**Huntley Square IS/MND (project ID: 2020-005 APN: 004-50-024)**

**FW: Huntley Square 7950 Bodega Ave Sebastopol, CA 95472**

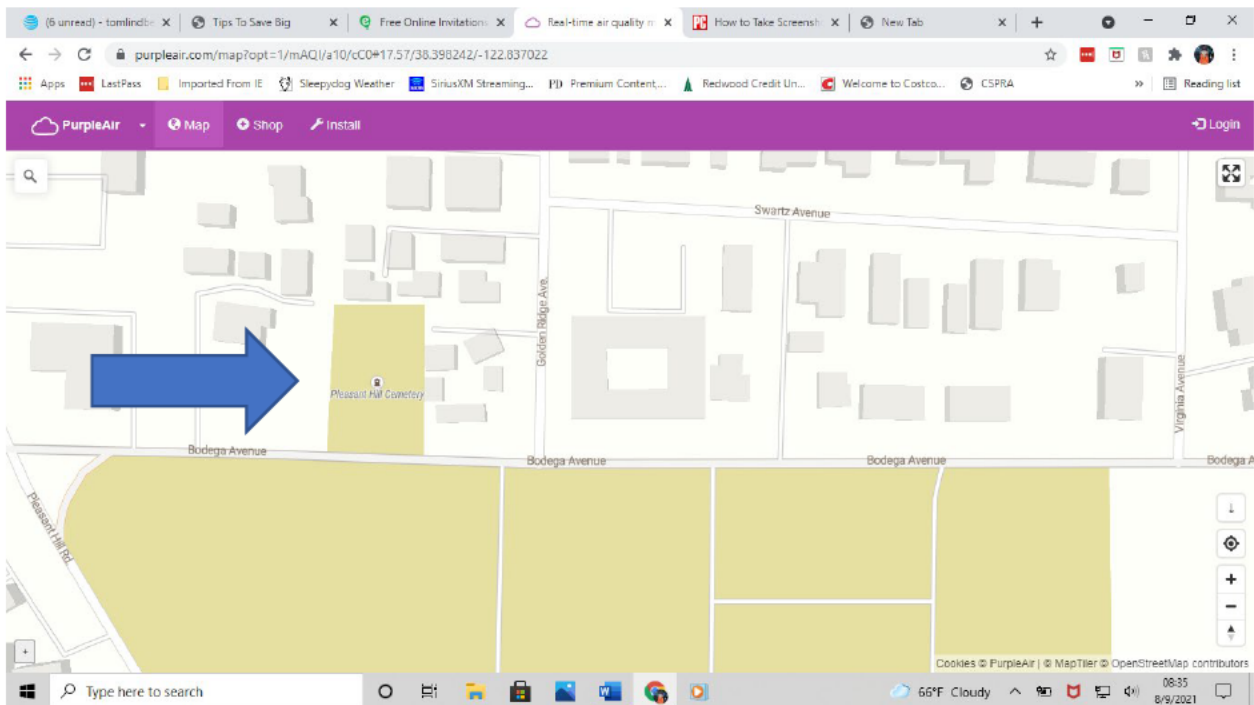
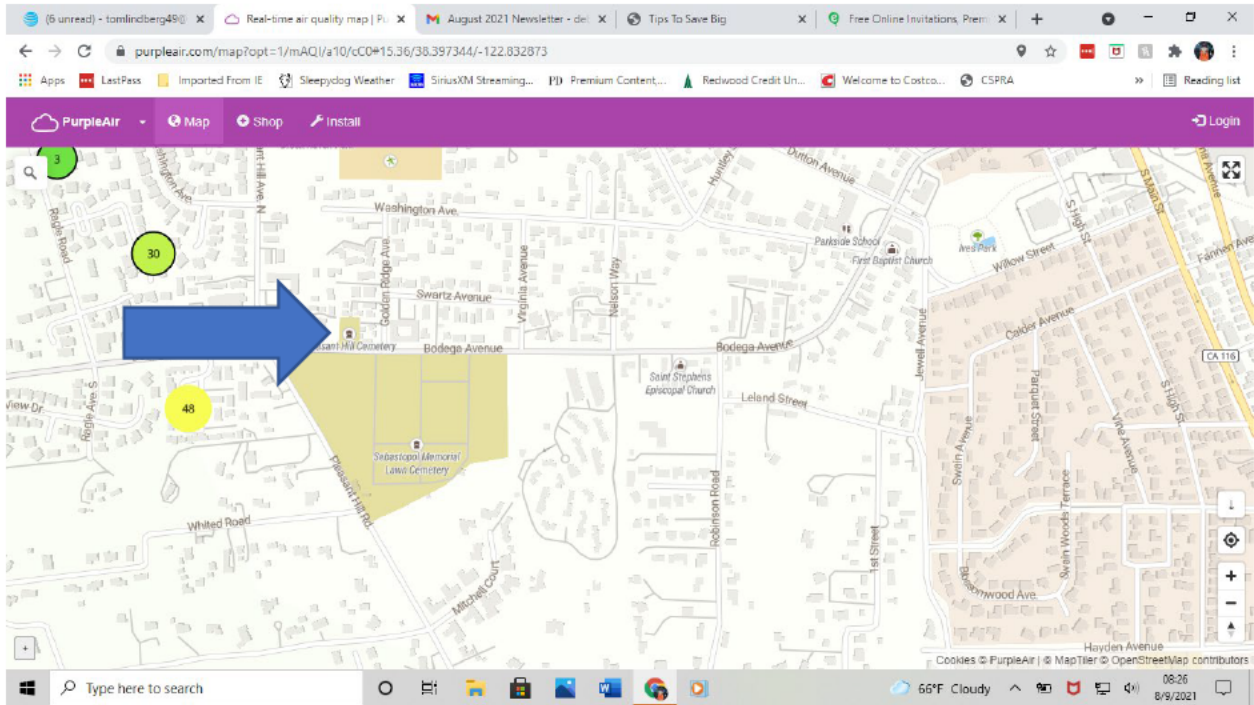
In this impact category are factors to consider including the scale of development originally considered for the site and surrounding areas. The .39-acre plot has had several earlier proposals that were for 2-4 homes. This project proposes 10 units and parking for 10 units.

Another aspect of Aesthetics as an environmental impact category is the issue of shade and shadow as it pertains to the blockage of direct sunlight and how it affects adjacent properties. Along the eastern border of the project will be five ganged-together units ranging as high as 24 feet. The set-back sought in the request for zoning change puts this row of attached units 8 feet from the fences of the existing townhomes in the Bodega Flats townhouses. Additionally, the Planned Community proposed standard for a non-residential accessory building height is 15 feet with a 1-foot setback from the existing 7-foot fences of the three Bodega Flats along the eastern border.

These monolithic structures will clearly block all afternoon sun for the existing adjacent townhouses in addition to all sunsets. Another loss will be the westerly breezes from the Pacific Ocean that we depend on for air circulation. The planned bank of mini-townhouses will loom over the existing yards and townhouses and block both sun and air. In addition to the 24-foot structure 8 feet from the existing 7-foot fences, there appear from the rendering to be balcony/porches that will almost look directly down into the existing yards.
